Memo

Re: Responses to comments from Zarin & Steinmetz, regarding Garvies Point PUD
Amendment and E/F Site Plan Applications

Date: REVISED June 15, 2021

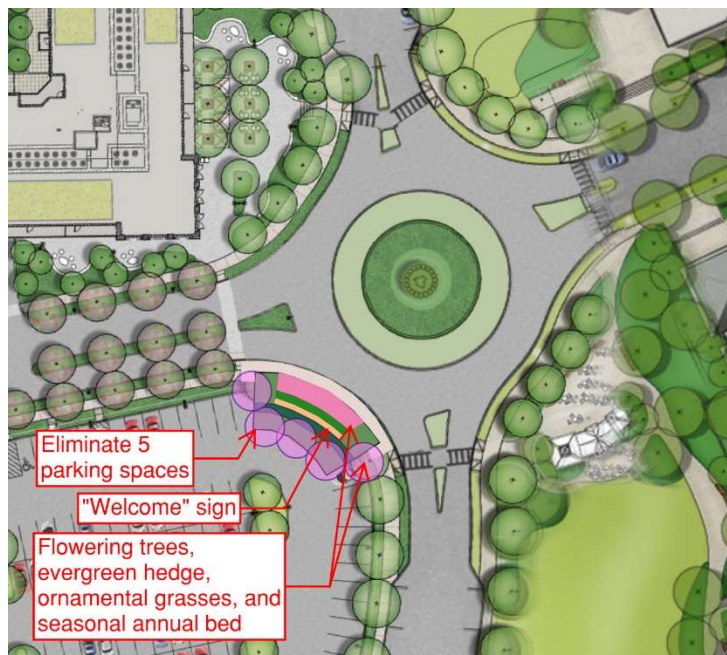
9. Clarify what dimensional requirements may not be met in the Block D surface parking lot.

However, in response to the discussion held between Saratoga Associates and the Applicant on 5/7/2021 and as detailed in the MPFP response memos, the Applicant is proposing to convert 5 parking spaces into signage and plantings at the northeast corner of Block D. See below for a graphic, which will be further detailed in a revised submission:

RESPONSE: *As discussed in other response memos, the Applicant has adhered to the City of Glen Cove's request to maximize parking at Block D, to maximize the potential ridership of the ferry service. This has entailed a reduction of the parking lot landscaping requirements that may have been stipulated in other zoning districts.*

Block A Parkland Section

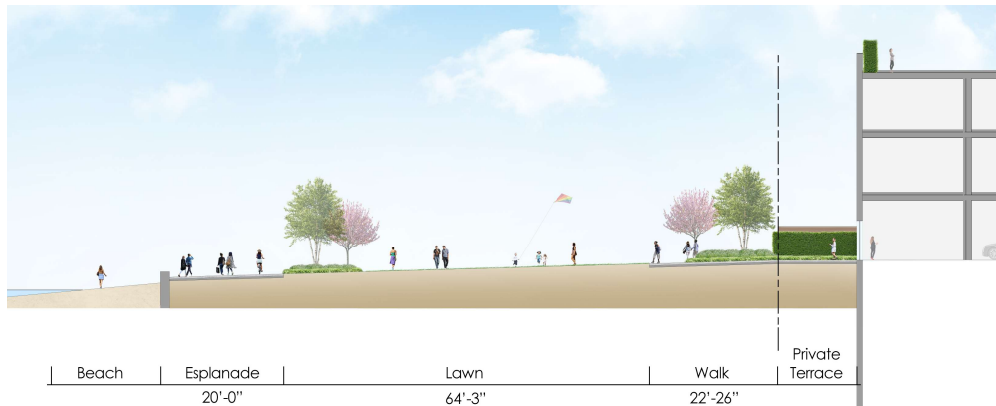
4. Describe how the restaurant on Block A would contribute to the public's enjoyment of the waterfront. Provide visuals showing views from the restaurant through the open space and towards Hempstead Harbor. The Technical Memorandum mentions that the restaurant elevation would be slightly higher than the water.

In front of the restaurant, the parkland slopes gradually down to the esplanade, but the restaurant terrace will be flush with the adjacent parkland. This will enable connectivity between the restaurant and the parkland and allow for the activity and the energy of the restaurant to "cross-pollinate" with the parkland. See section shown in Attachment 2 for reference, which was part of the presentation to the Planning Board in January.
